P-13345-1

S4016

SYMBOL OF QUALITY AN ISO 9001 COMPANY	JINDAL ALUMINIUM LTD. BANGALORE-560073 (INDIA)	NAME		DATE
		DRAWN	J.P.KAUSHIK	02-04-2014
1. ALL DIMENSIONS ARE IN mm. 2. ROUND OFF ALL SHARP CORNERS WITH 0.40 mm. 3. TOLERANCES WILL BE AS PER IS:6477-1983 , UNLESS OTHERWISE SPECIFIED		CHECKED		
		APPROVED	S.S.GARG	15-04-2014
PARTY'S NAME RABWIN INDUSTRIES PVT. LTD., COIMBATORE		SCALE		0.5:1
		AREA mm ²		24278.228
PARTY'S DRAWING No. AS PER SPECIFICATION		PERIMETER mm.		710
		WEIGHT kg/m		65.551
ALLOY & TEMPER 6082 T6		DRAWING No.	SECTION No.	
		P-13345-1	-	
DESCRIPTION ROUND TUBE		S4016	S4016(ISSUE-2)	
		13656	13656

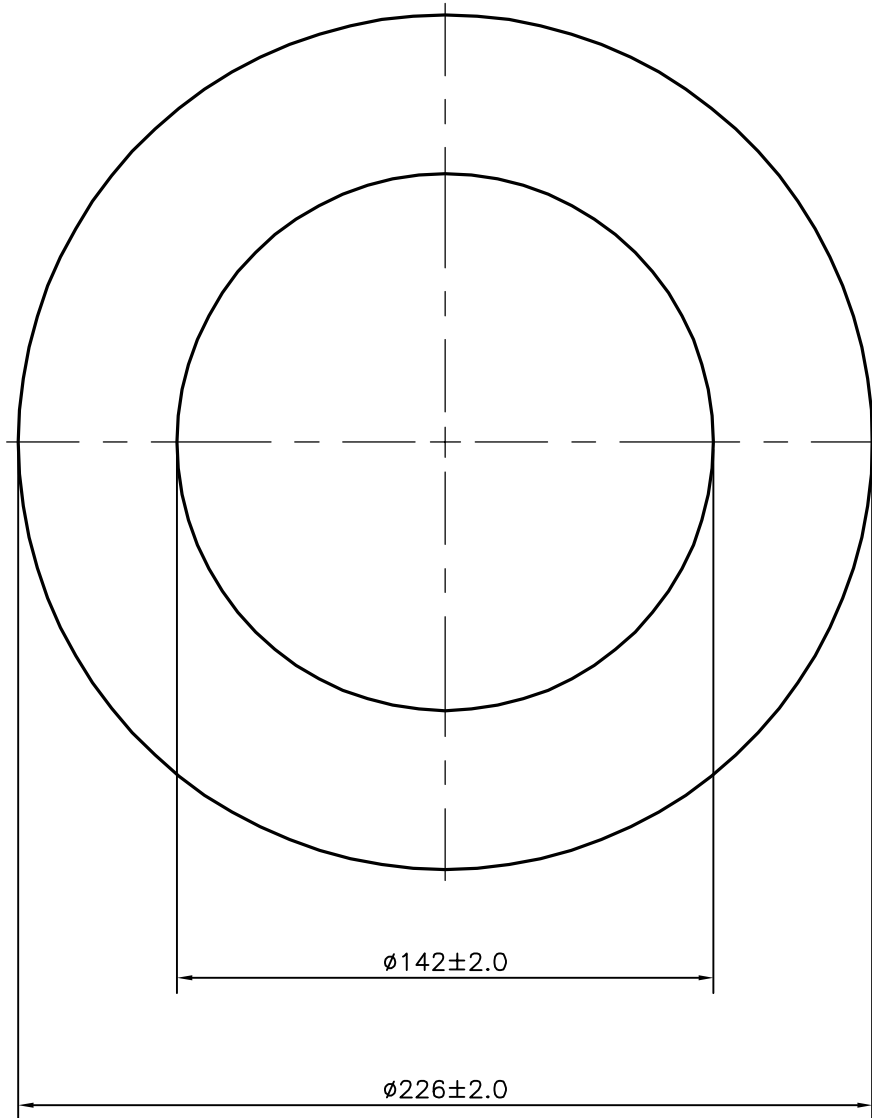
ISSUE-2:- DIMENSION CHANGED FROM $\phi 224$ mm TO $\phi 226$ mm
 WEIGHT ALSO CHANGED 63.643 kg/M TO 65.551 kg/M
